Model: Kir-C	Date: 30-May-01	No.: MB040001b
--------------	-----------------	----------------

MB Correction

Modified Article: Parts Catalog Correction		Prepared by: K. Miura	
From: Technical Services Dept., GTS Division			
Reason for Modification:	☒ Parts catalog correction	☐ Vendor change	☐ To meet standards ()
	☐ To facilitate assembly	☐ To improve reliability	
	☐ Part standardization	☐ Other

Page 9

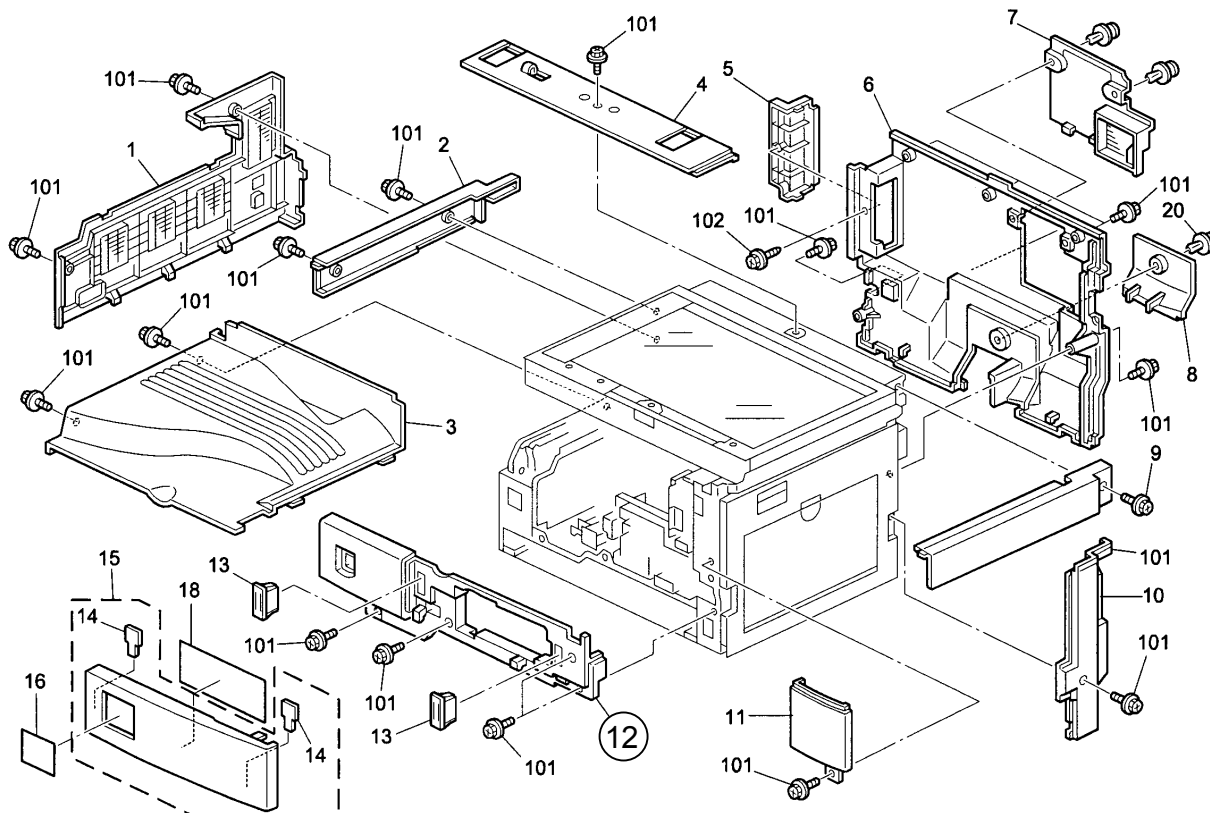
Part number	Old description	New description	Q'ty	Index	Note
B0391350	Front Cover (EU)	Front Cover (EU/ASIA/TWN)	1	12

Part number	Description	Q'ty	Index	Note
B0391352	Front Cover (CHN)	1	12

Page 11

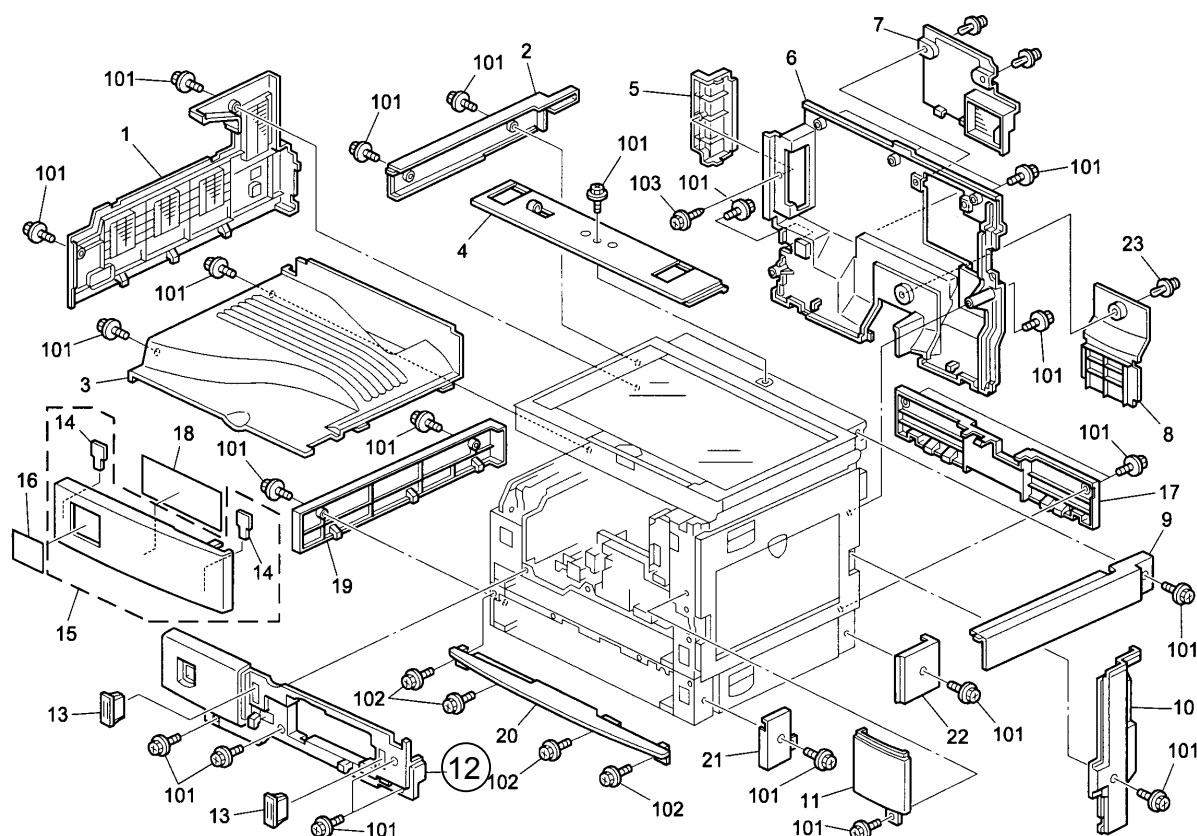
Part number	Old description	New description	Q'ty	Index	Note
B0391350	Front Cover (EU)	Front Cover (EU/ASIA/TWN)	1	12

Part number	Description	Q'ty	Index	Note
B0391352	Front Cover (CHN)	1	12

Page 25

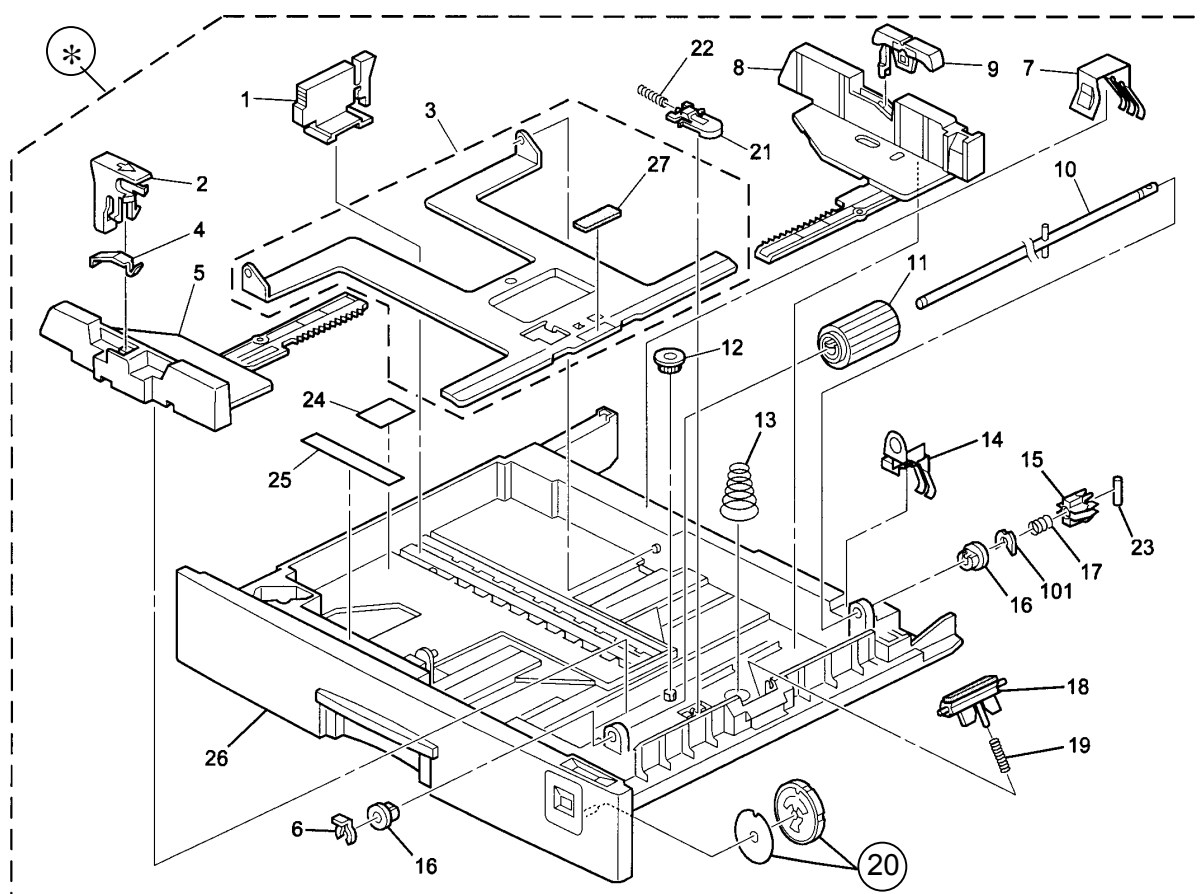
Part number	Description	Q'ty	Index	Note
B0392791	Paper Tray Assembly – A4 (CHN)	1	*	
B0392778	Paper Size Detector – A4 (CHN)	1	20

Page 27

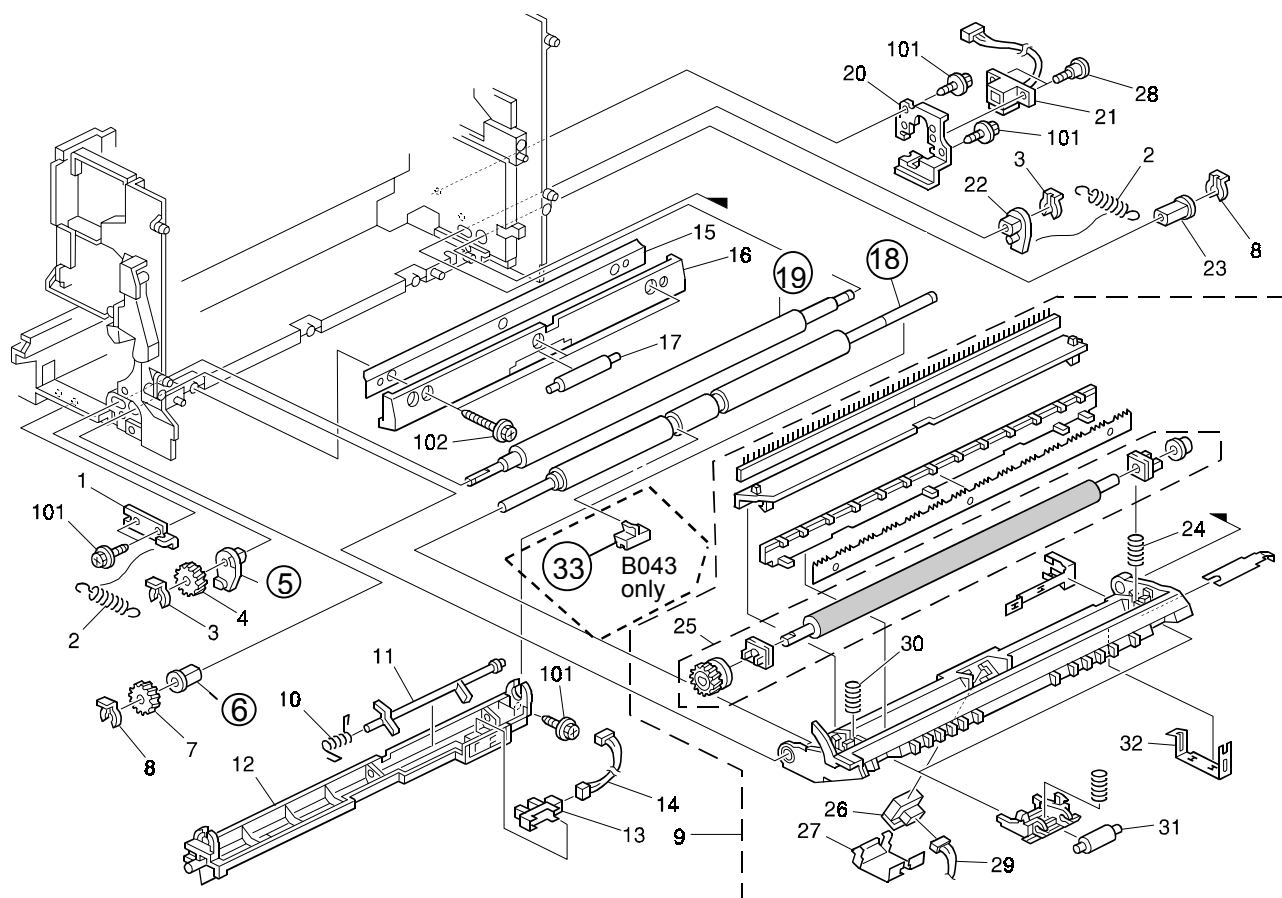
- Illustration Change -

Part number	Description	Q'ty	Index	Note
B0432554	Registration Guide Spacer	1	33

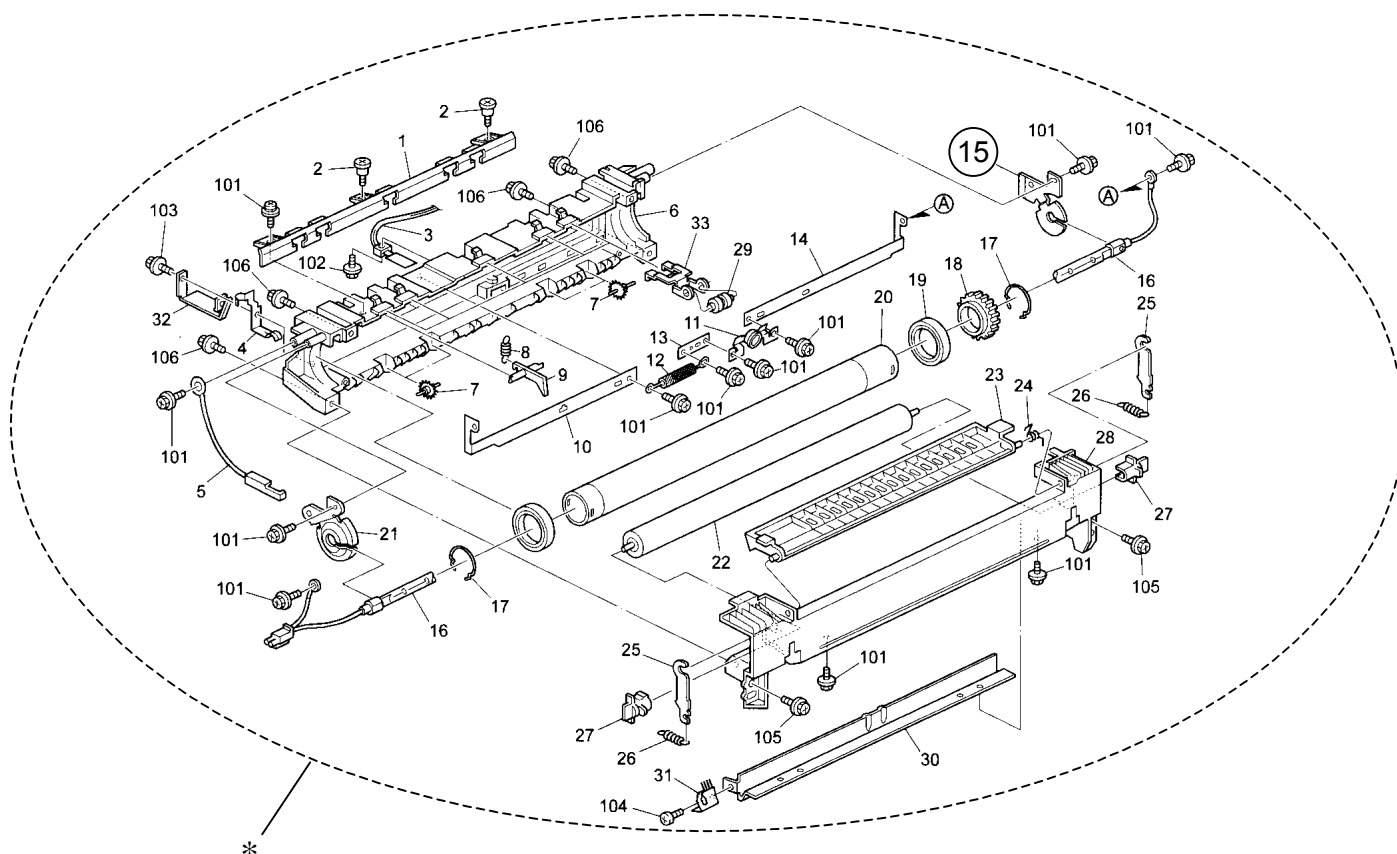
Old part number	New part number	Description	Q'ty	Int	Page	Index	Note
B0394018	B0394019	Fusing Unit – 120V	1	X/O	41	*	
B0394028	B0394029	Fusing Unit – 230V	1	X/O	41	*	
B0394139	B0394140	Rear Holder	1	X/O	41	15

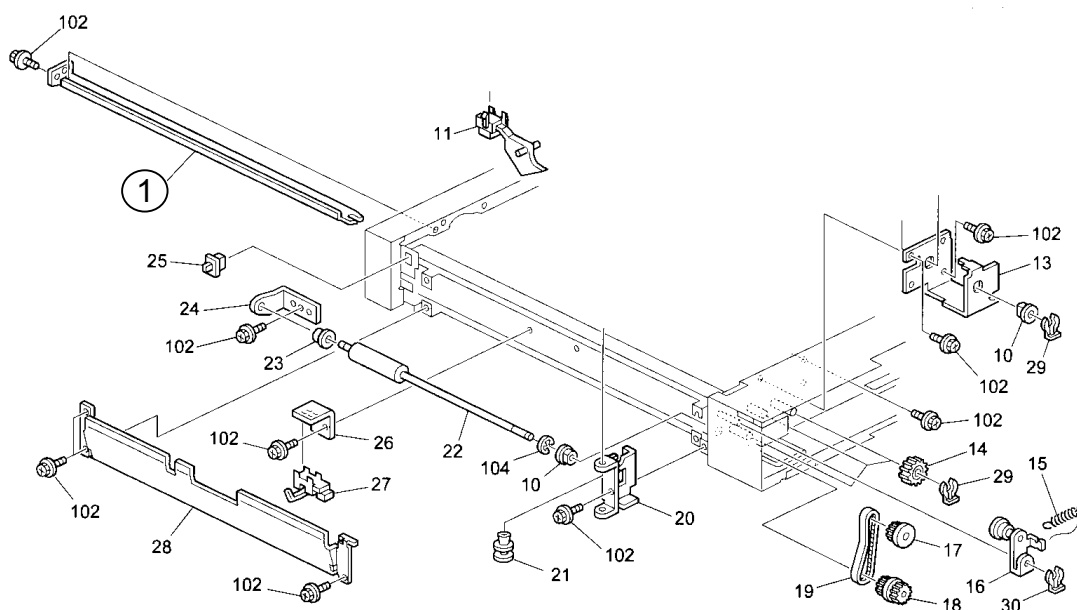
Old part number	New part number	Description	Q'ty	Int	Page	Index	Note
B0406061	B0406150	Guide Plate – Upper Paper Feed	1	X/O	31	1

Modified Article: Right Door		Prepared by: K. Miura	
From: Technical Services Dept., GTS Division			
Reason for Modification:	☐ Parts catalog correction	☐ Vendor change	☐ To meet standards ()
	☐ To facilitate assembly	☒ To improve reliability	
	☐ Part standardization	☐ Other

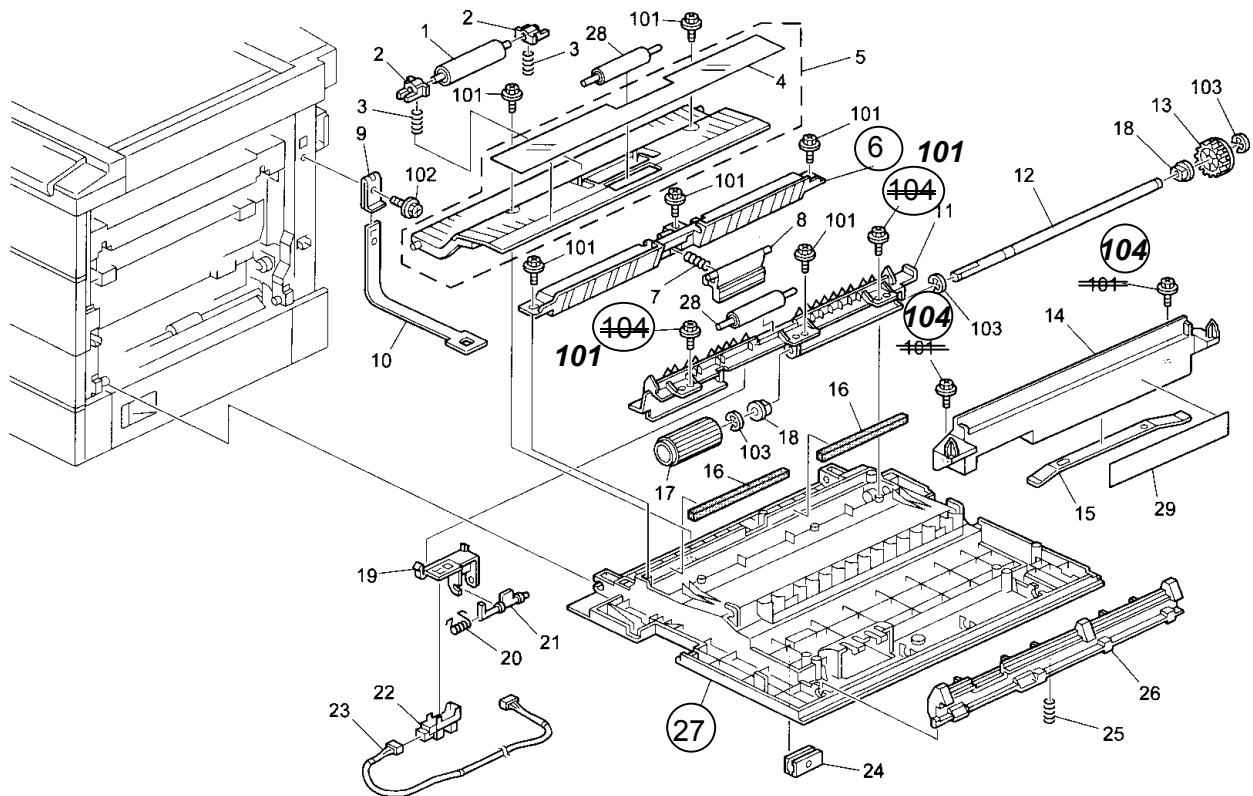
The following parts have been modified to increase the durability of the Right Door screw holes and openings and ensure that cracks do not form. In addition, please note the new index number for the Stepped Screw (#104).

Old part number	New part number	Description	Q'ty	Int	Page	Index	Note
B0392608	B0392607	Lower Guide Plate – By-Pass Feed	1	X/X	33	6	
B0392650	B0392670	Right Door	1	X/X	33	27	
04503008B	B0394480	Stepped Screw – M5	2	X/X	33	101 → 104

Note: All parts listed above must be replaced together as a set.

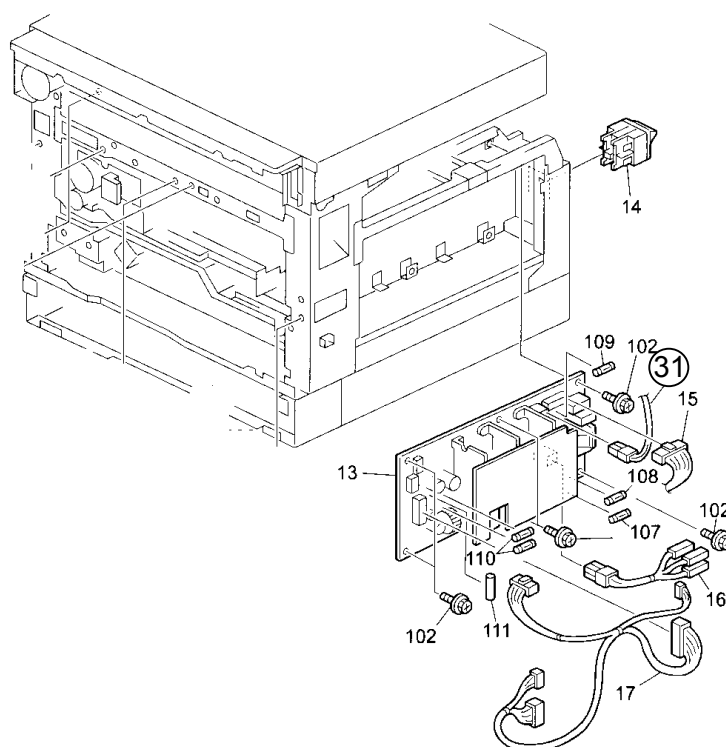
The shape of the Fusing AC Harness has been changed so that the Fusing Unit can only be physically installed into mainframes with the correct (corresponding) voltage.

Old part number	New part number	Description	Q'ty	Int	Page	Index	Note
B0395216	B0395218	Fusing AC Harness	1	X/O	53	31

Modified Article: Registration Guide Spacer		Prepared by: K. Miura	
From: Technical Services Dept., GTS Division			
Reason for Modification:	☐ Parts catalog correction	☐ Vendor change	☐ To meet standards ()
	☐ To facilitate assembly	☒ To improve reliability	
	☐ Part standardization	☐ Other

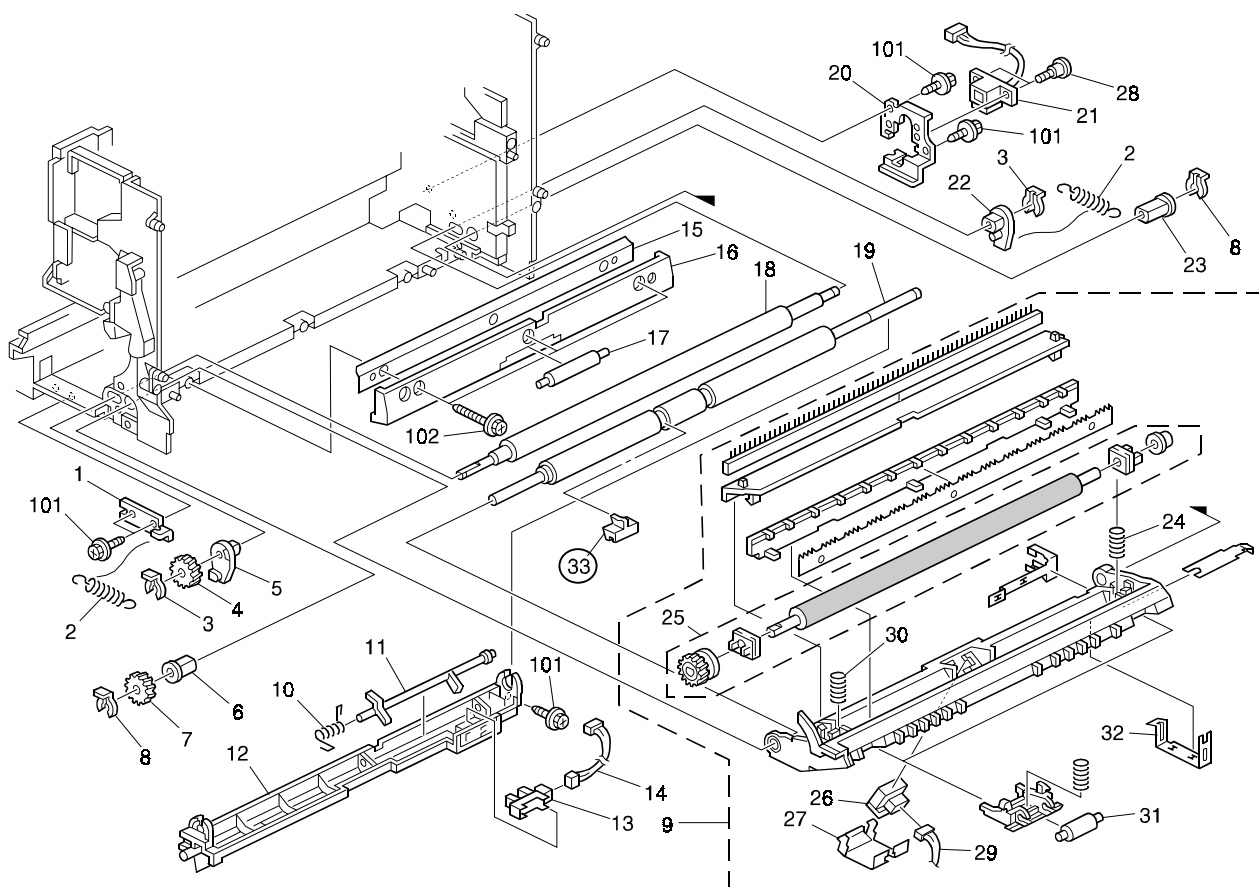
A Registration Guide Spacer has been added to ensure that the Registration Roller Spring stays properly in place.

Old part number	New part number	Description	Q'ty	Int	Page	Index	Note
	B0432554	Registration Guide Spacer	1		27	33

Note: This part has already been added from the beginning of mass production of the B043 Duplex model (see MB040001b).

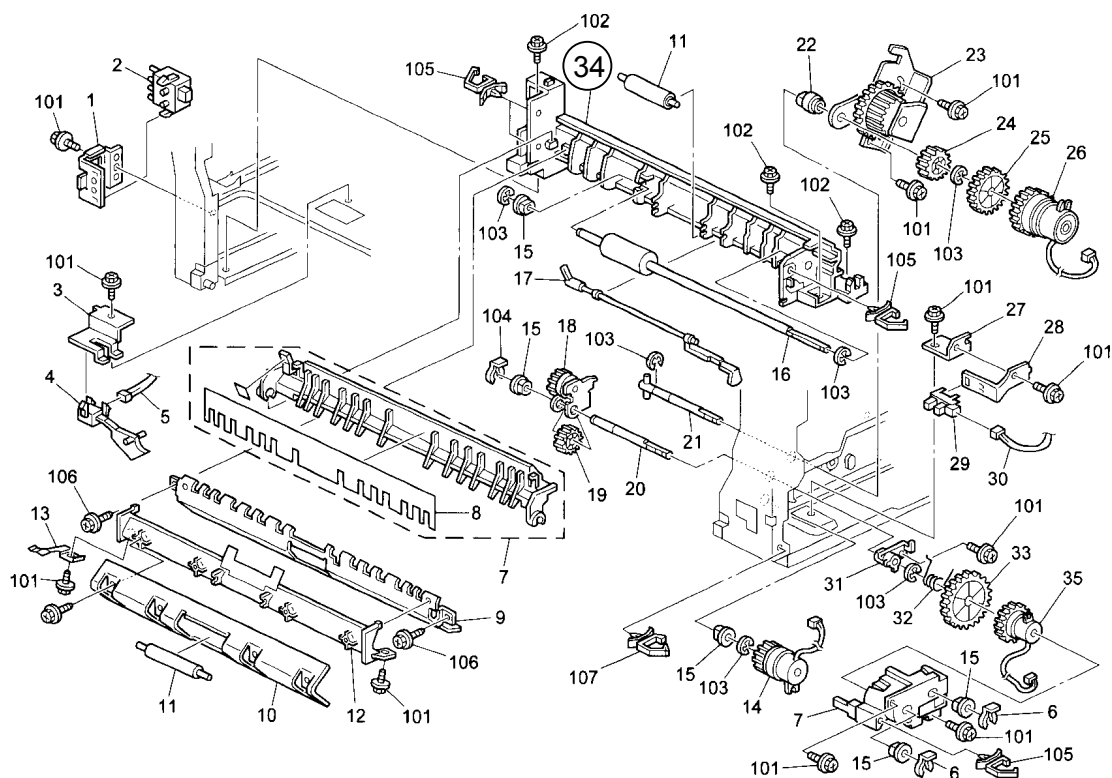
The Right Rail has been modified to minimize noise.

Old part number	New part number	Description	Q'ty	Int	Page	Index	Note
B0392750	B0392830	Right Rail	1	X/O	29	34

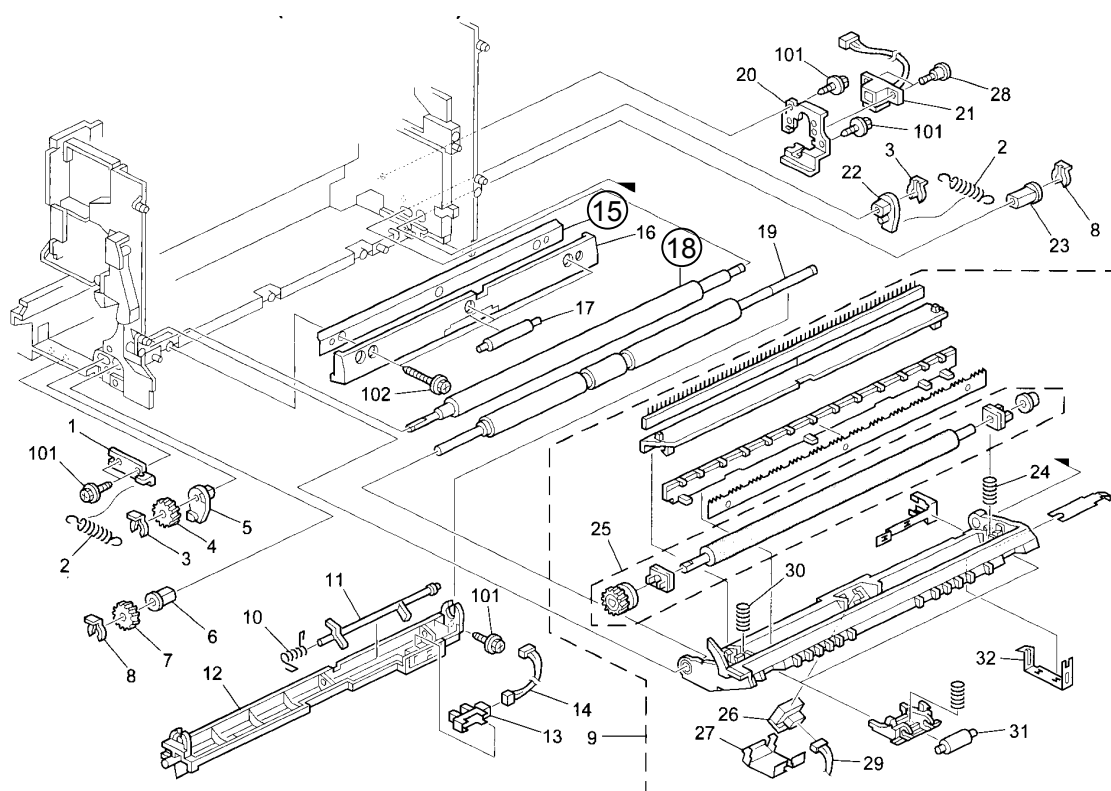
When printing out onto A3 or DLT (11x17") paper, copies can show creasing and/or reduced ID lines that appear like creases. To ensure this does not occur, the following parts have been changed.

Old part number	New part number	Description	Q'ty	Int	Page	Index	Note
B0392559	B0392560	Registration Cleaning Mylar	1	X/O	27	15	
AF021069	AF021080	Left Registration Roller	1	X/O	27	18
